# Wisconsin Department of Transportation

**Proposal #09: 1220-21-60, WISC 2022 463**  
**IH 43, City of Green Bay**  
**Leo Frigo Bridge, B050158**  
**IH 43**  
**Brown County**

This is Addendum No. 02, which provides for the following:

**ADDENDUM NO. 02**

Addendum No. 02  
 ID 1220-21-60  
 Revised Sheet 66  
 June 13, 2022

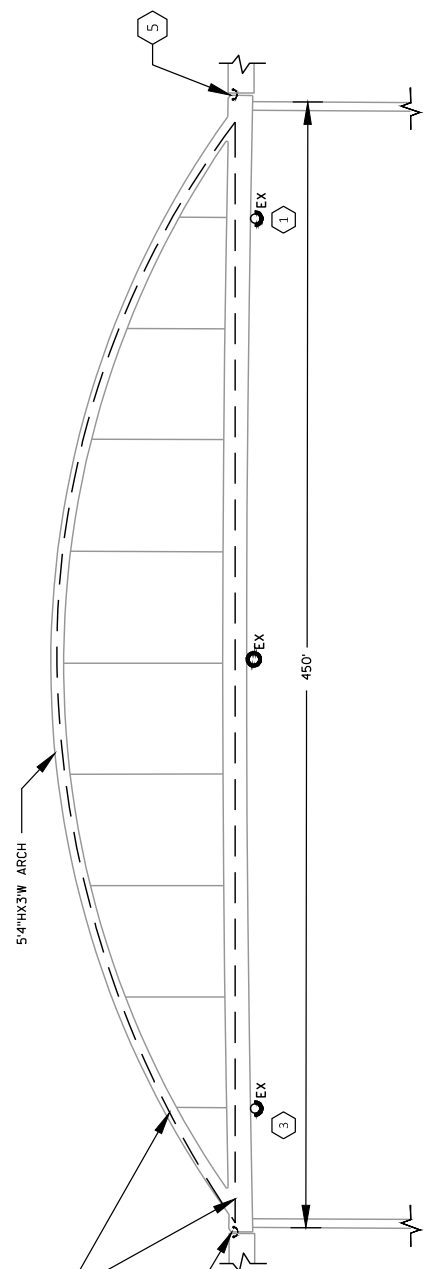
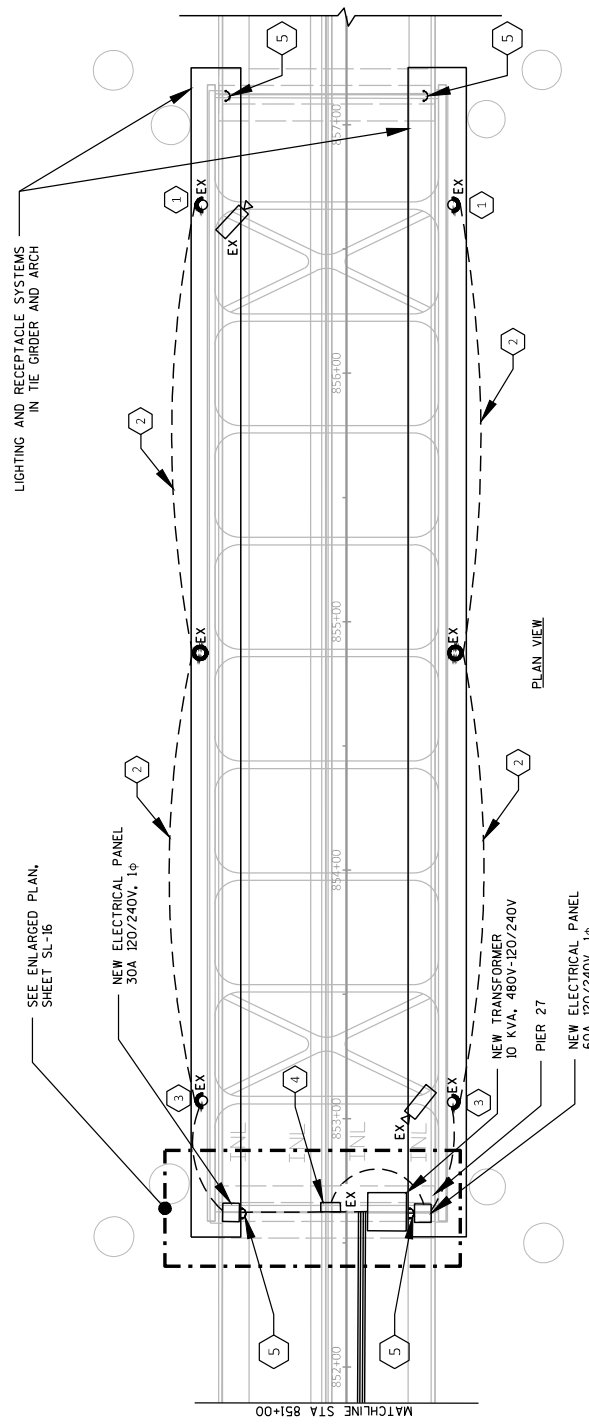
Revised Plan Sheets	
Plan Sheet	Plan Sheet Title (brief description of changes to sheet)
66	Lighting Plans – Construction Details (clarification on arch length)
77	Lighting Plans – Construction Details (revision to length of continuous LED rope lighting)

INSTALL MAINTENANCE/INSPECTION LIGHTING AND RECEPTACLES INSIDE 911"x31" IE ORDERS AND 54"x3" ARCH. APPROXIMATELY 15' FROM ONE END. CONTINUOUS STRIP LIGHT FROM ONE END TO THE OTHER THROUGH EACH ARCH

Addendum No. 02  
ID 1220-21-60  
Revised Sheet 77  
June 13, 2022

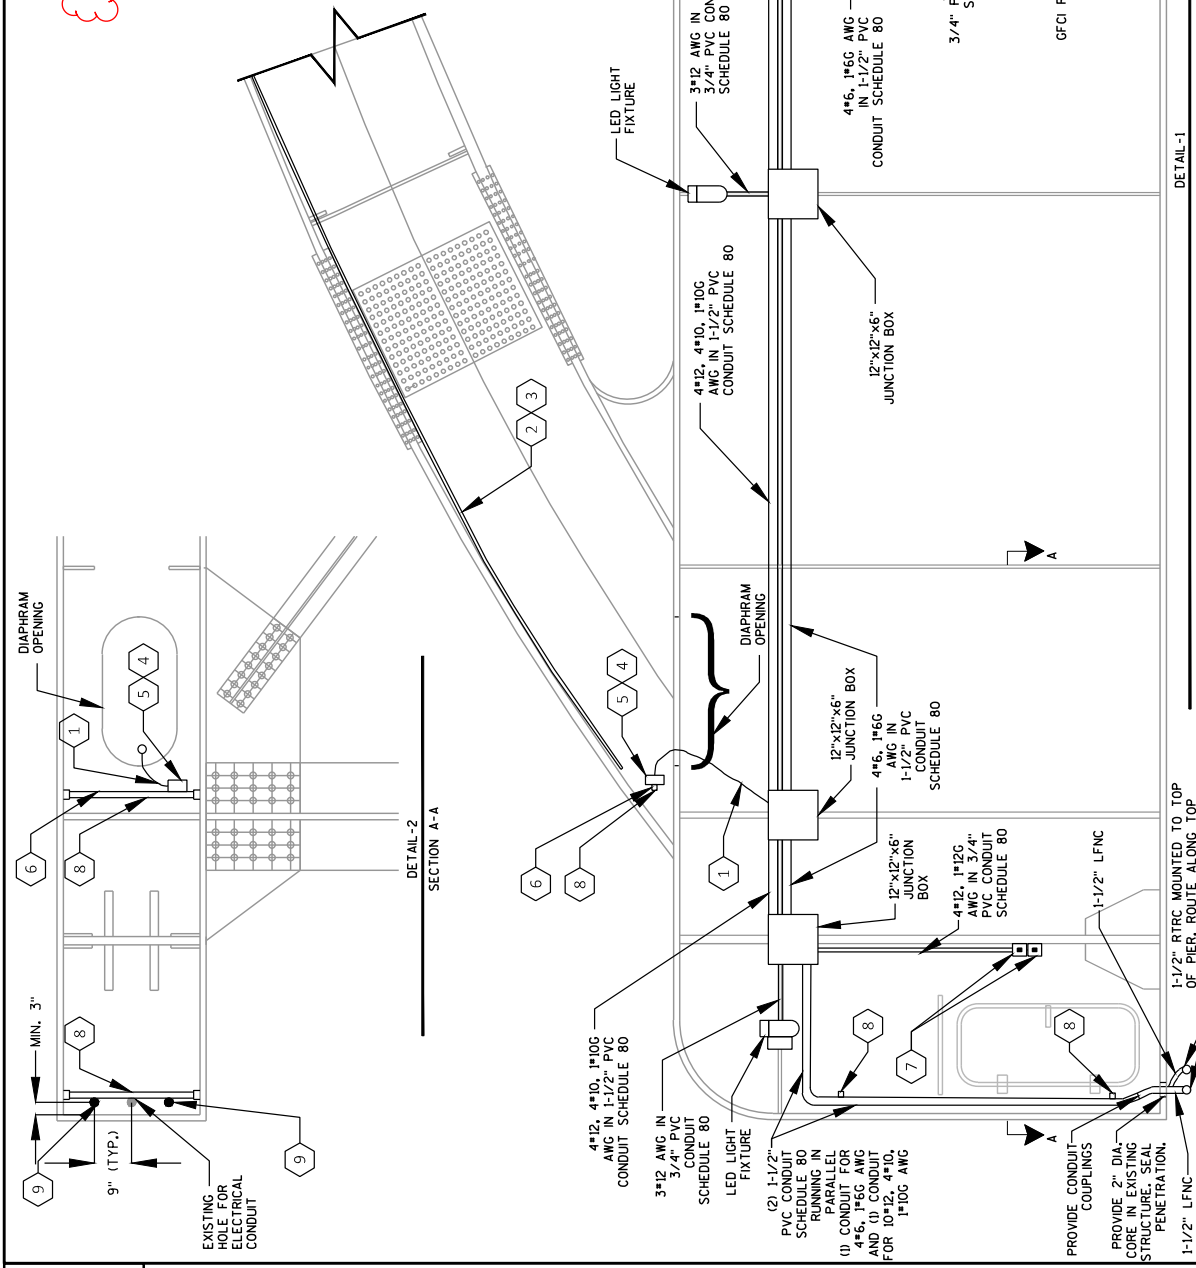
1. PROVIDE LIQUID TIGHT FLEXIBLE CONDUIT WITH THE TWO CIRCUITS, 6\*12, 1\*12G AWG IN 3/4" LFNC CONDUIT. PROVIDE 482 FT (MIN) OF CONTINUOUS LED ROPE LIGHTING. TO BE PLUGGED IN ON THE EAST END OF THE ARCH.

2. PROVIDE A REDUNDANT LED ROPE LIGHT SYSTEM INSTALLED IN THE OTHER CORNER OF THE ARCH. DESIGN INTENT IS THAT THIS ROPE LIGHT SYSTEM WOULD NOT BE USED FOR NORMAL OPERATION. PROVIDE 500 FT OF CONTINUOUS LED ROPE LIGHTING. PLUG END TO BE LOCATED ON THE EAST END OF THE ARCH. PLUG SHALL NOT BE PLUGGED. COIL AND SAFELY STORE ABOVE IN ARCH.
